Measure C Bond Office

Subject: Addendum 2, Bid FB-25-02, Camarillo Heights STEM Academy, Campus
Fire Alarm Upgrades

Project: PVSD Camarillo Heights Elementary School 03-124308
Subject: Narrative for CCD-001 delta 1 regarding electrical changes to Contract Documents

E600

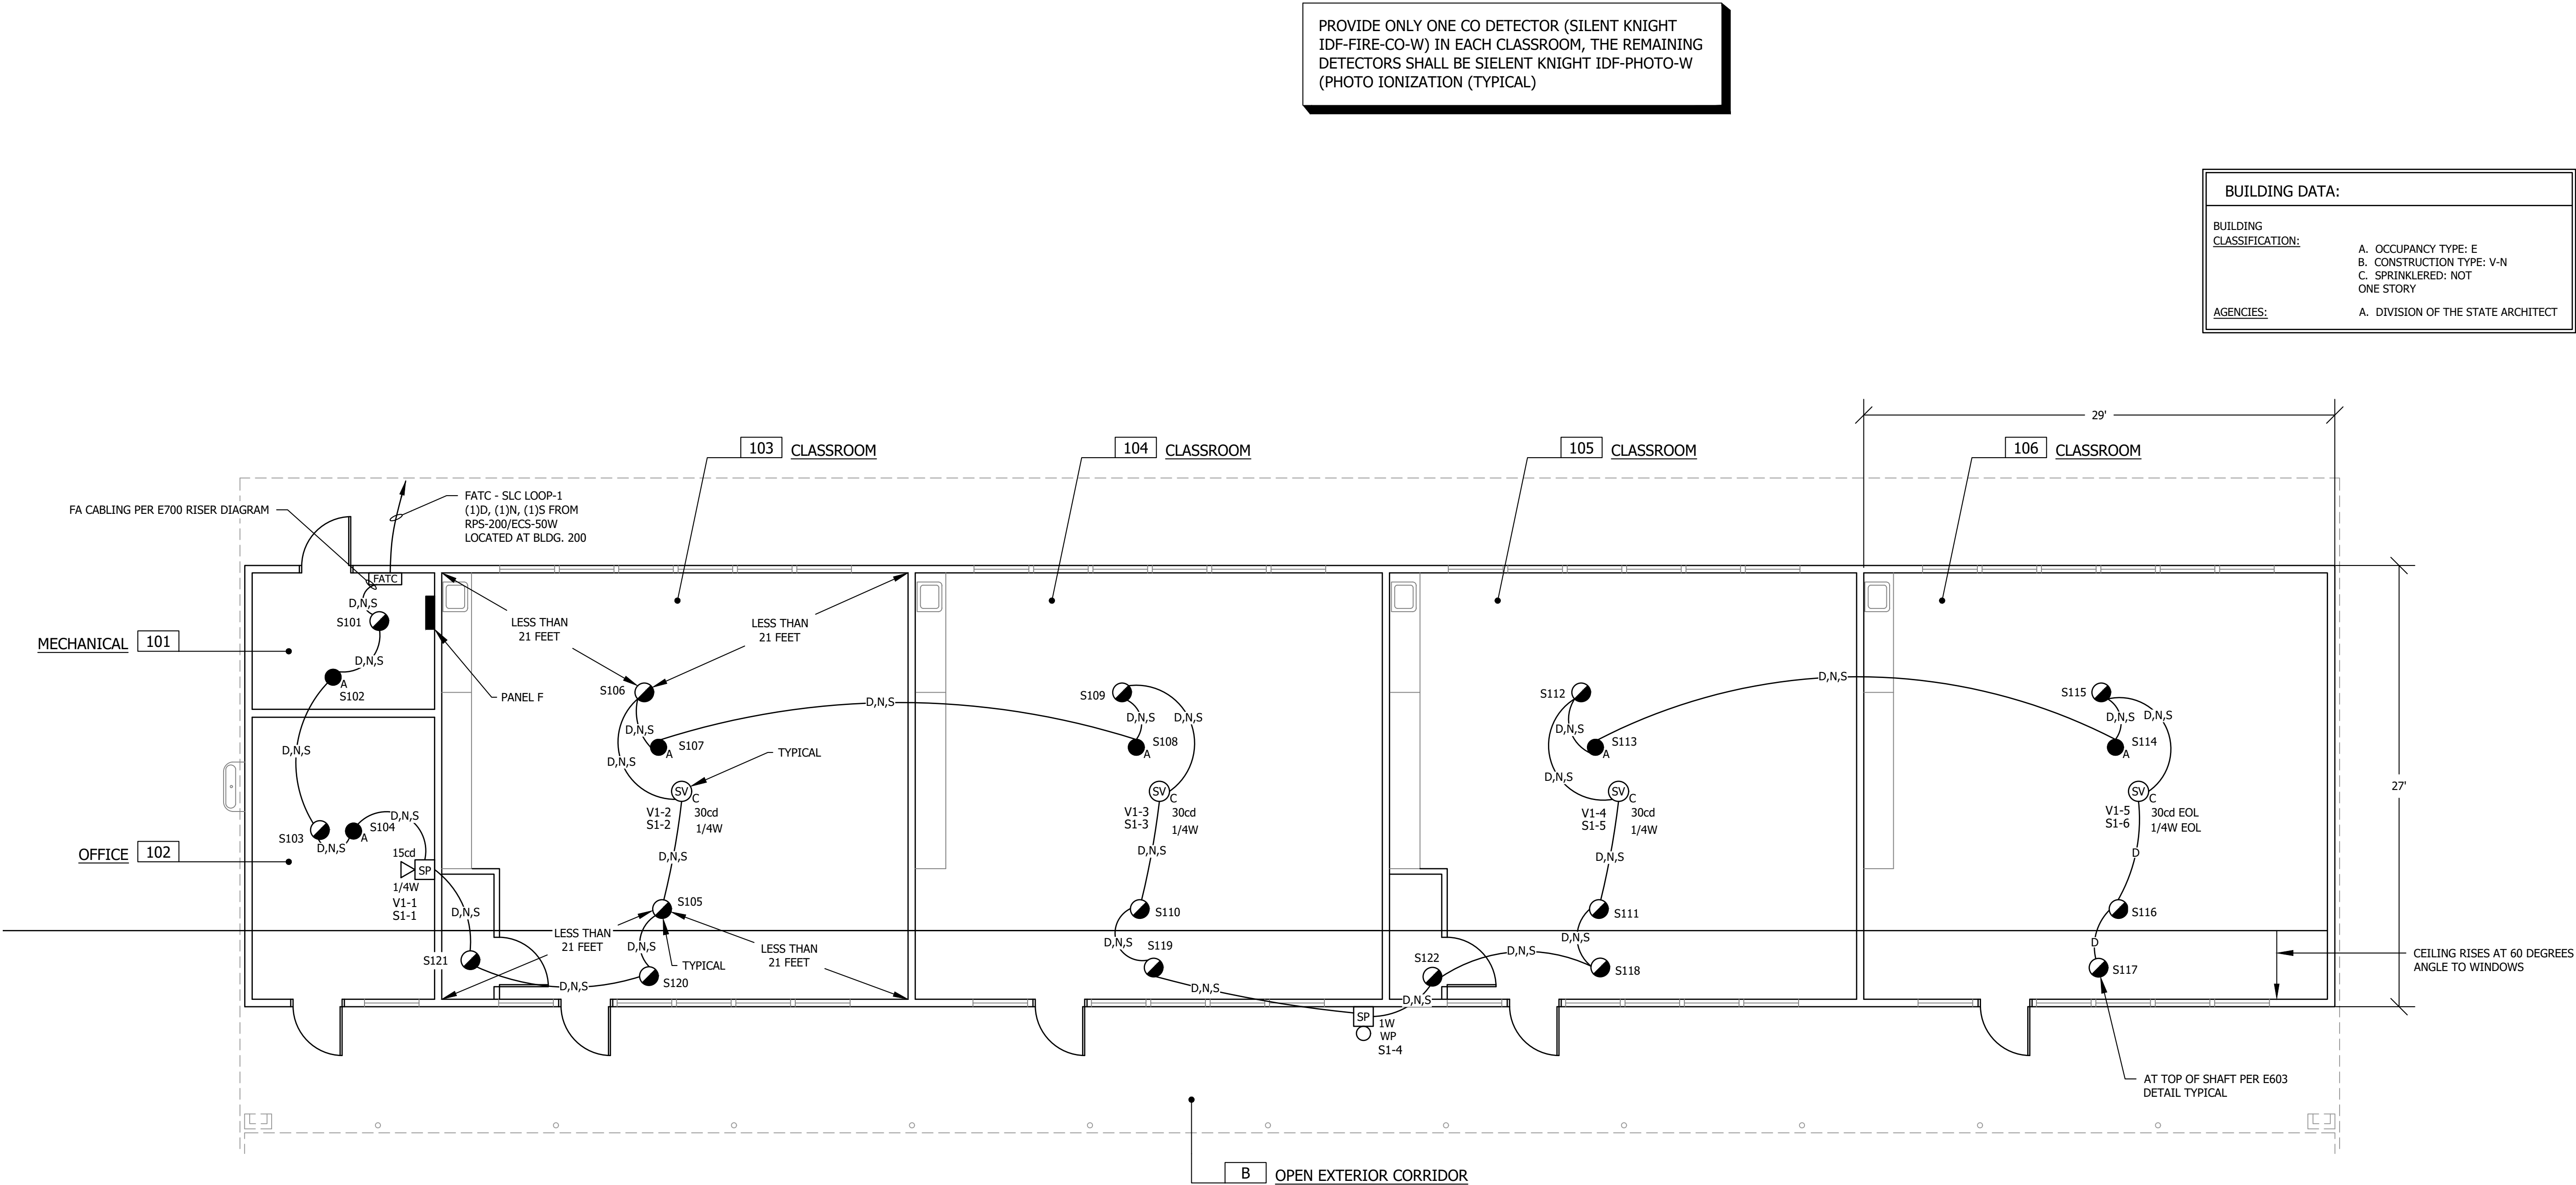
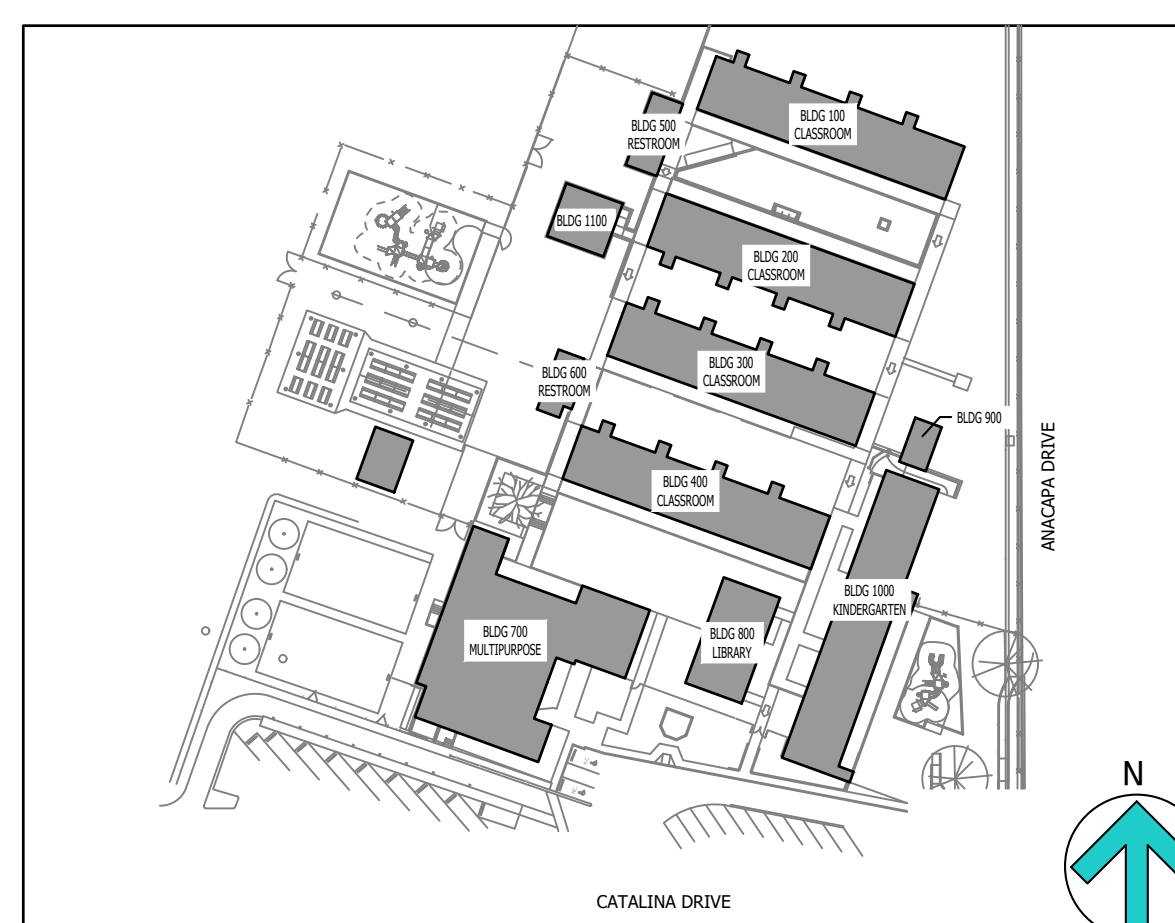
- Added note that Kitchen modular FA is already being completed in 02-122807 and is not included in this set
- Added site FA feeders from FACP to all RPS units and to building FATC for site interconnection.
- Added key notes denoted conduit sizes (cabling is shown on E700 & E701)
- Added general notes specific to the installation of the conduits on the site.

- KEY NOTES:**
- 1 1.5" C WITH FA CABLING PER E701.
 - 2 2" C WITH FA CABLING PER E701.
 - 3 1.25" C WITH FA CABLING PER E701.
 - 4 NEW PULLBOX NEMA 3R - 18" x 18" x 6", (LABEL 'FIRE ALARM').

E610

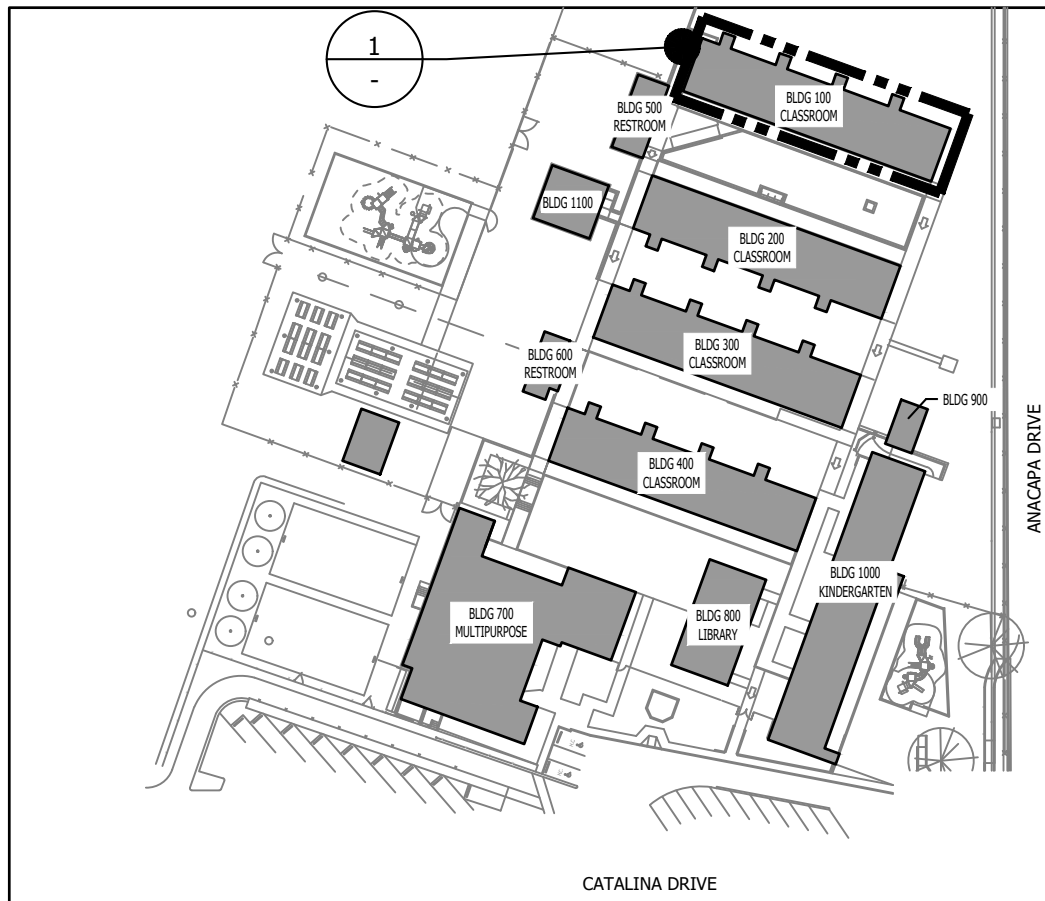
- Changed smoke detectors so only one CO (Carbon Monoxide) detector is needed in each room, the remaining detectors will be the Silent Knight IDF-PHOTO-W.

E680

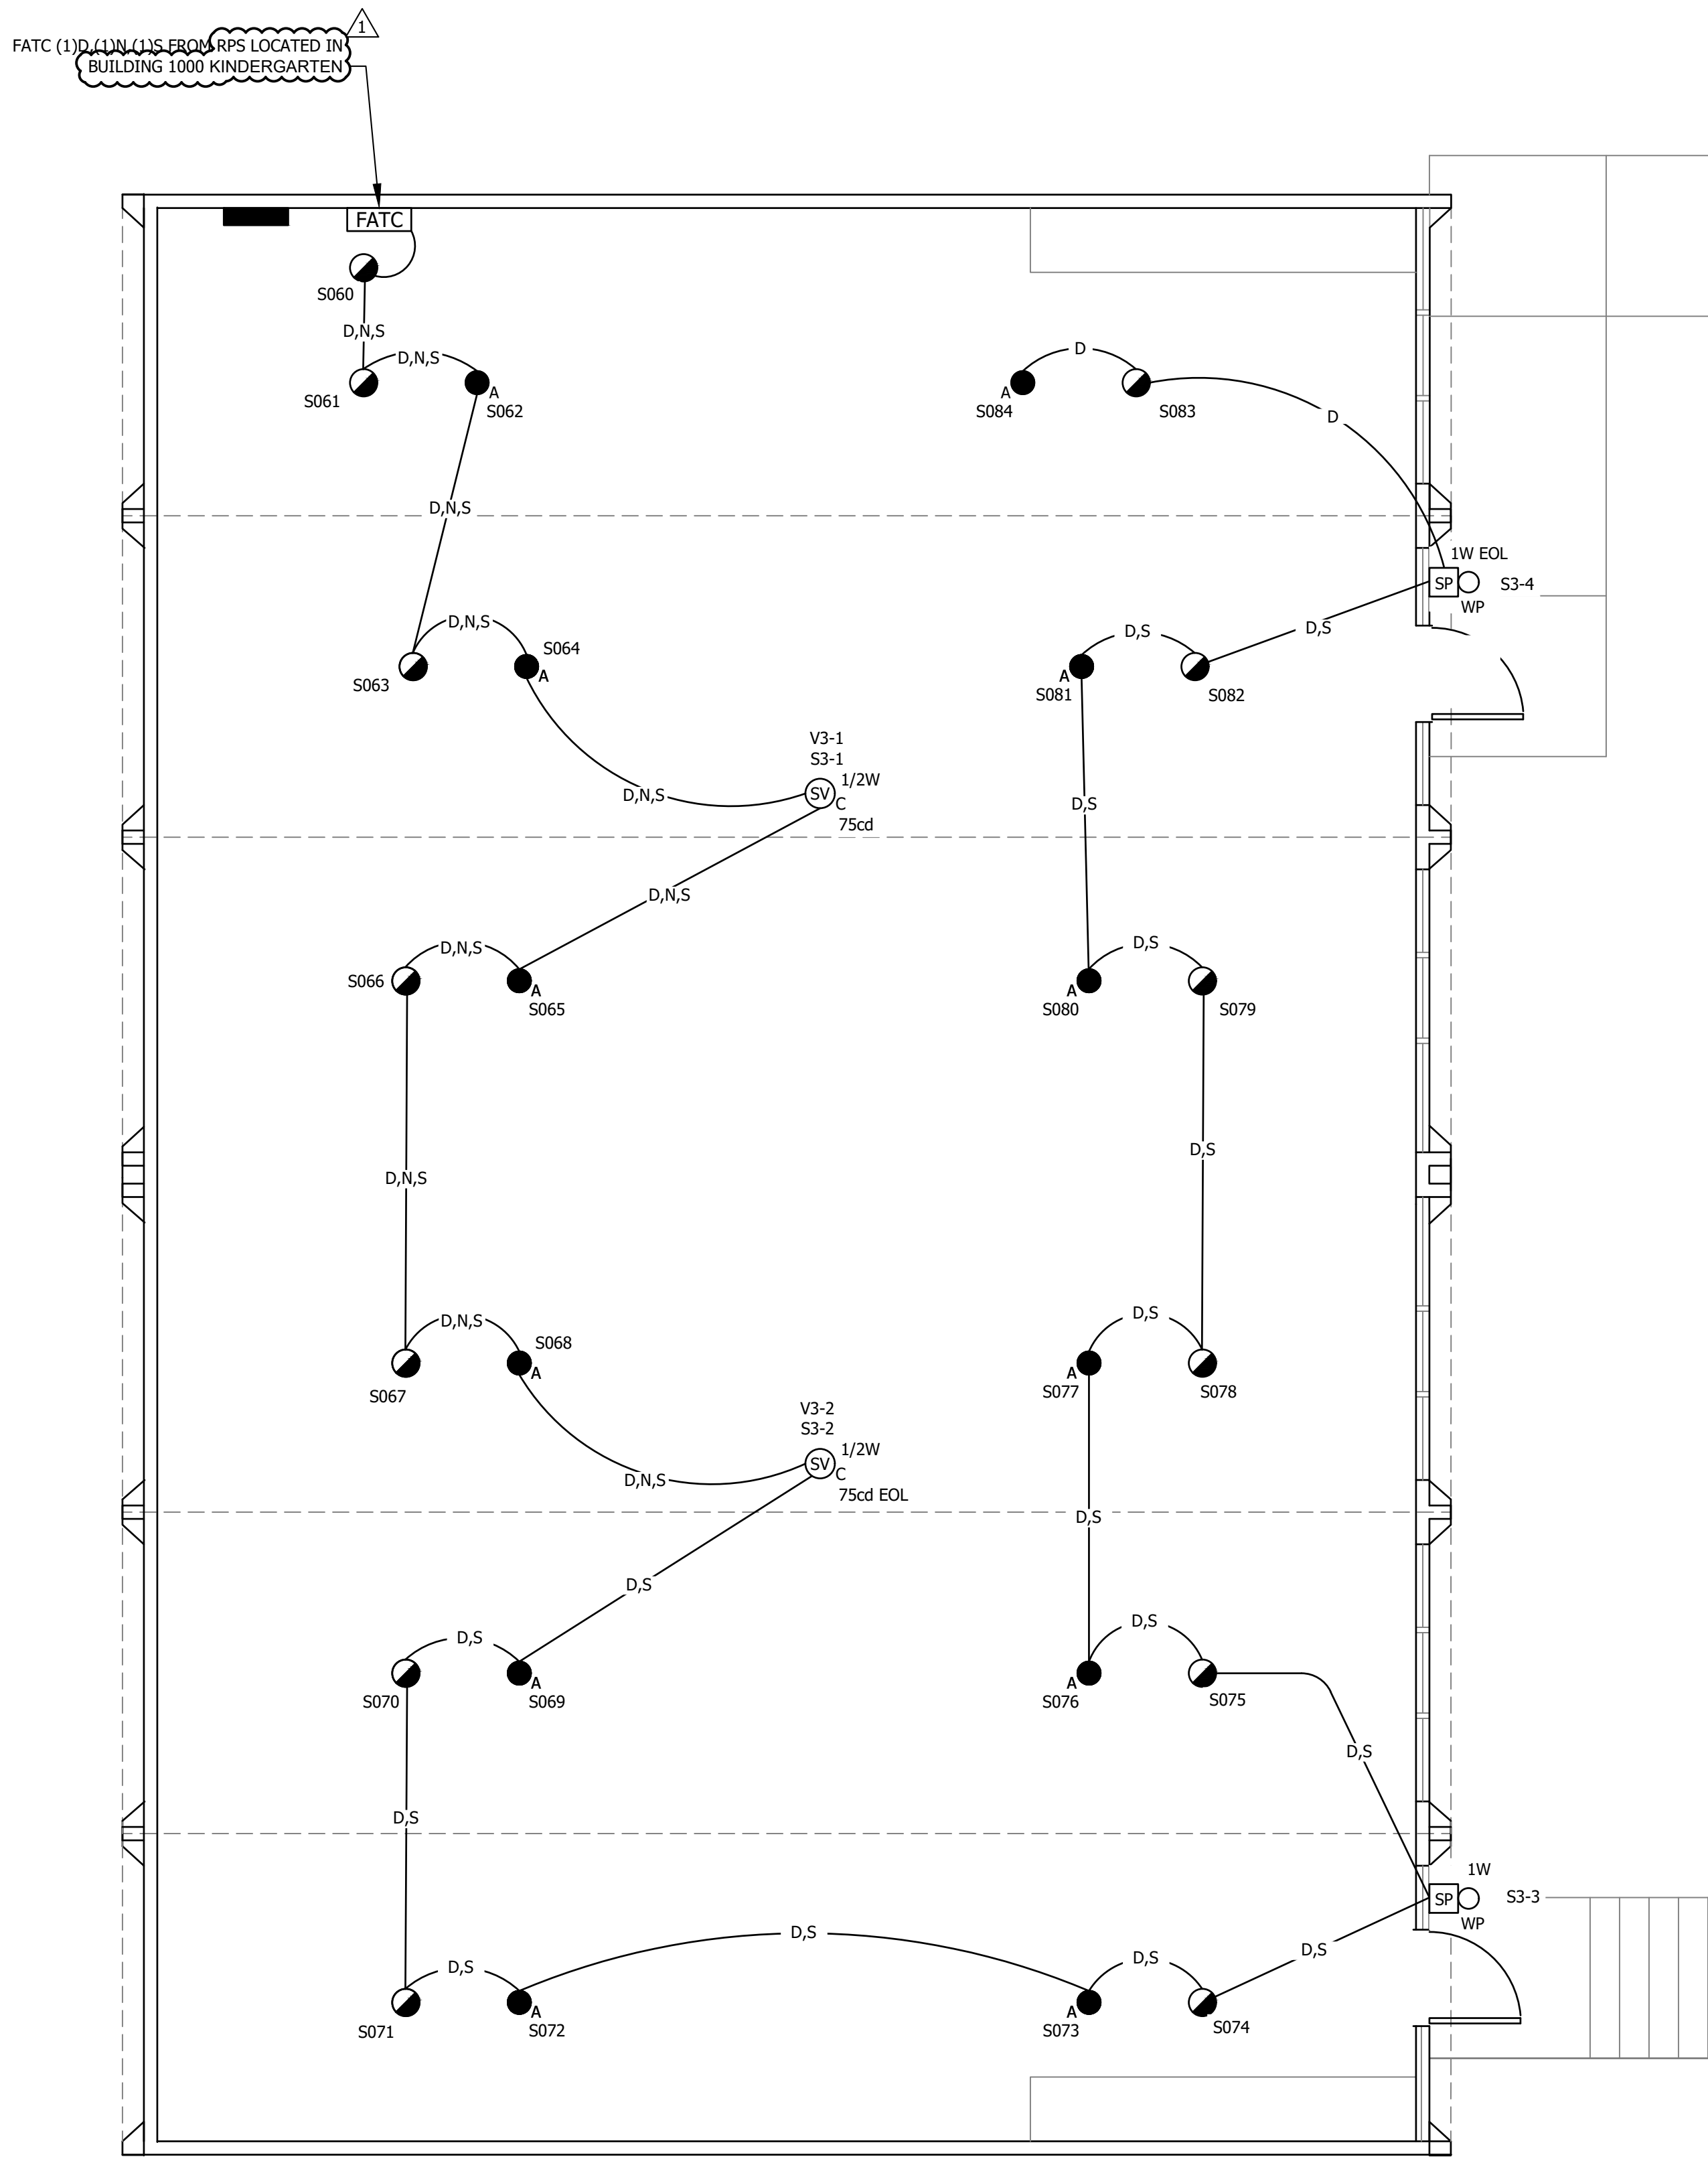
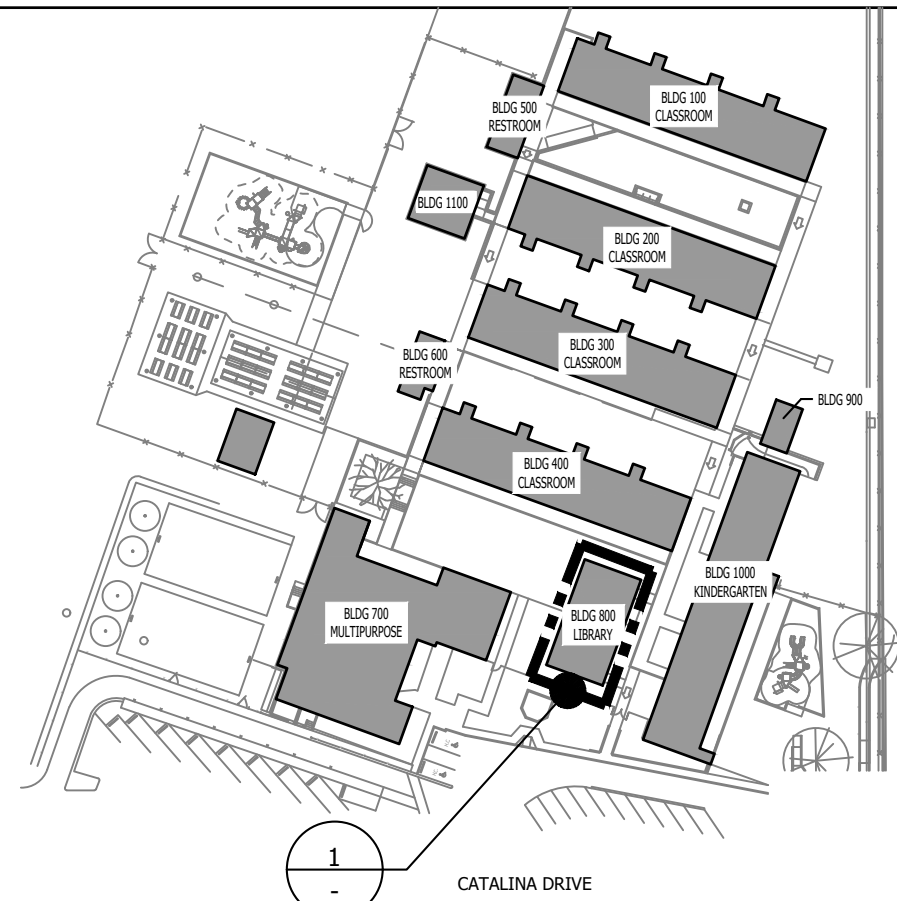
- Added note changing home run to be Building 1000 Kindergarten RPS

PROVIDE ONLY ONE CO DETECTOR (SILENT KNIGHT IDF-FIRE-CO-W) IN EACH CLASSROOM, THE REMAINING DETECTORS SHALL BE SILENT KNIGHT IDF-PHOTO-W (PHOTO IONIZATION (TYPICAL))
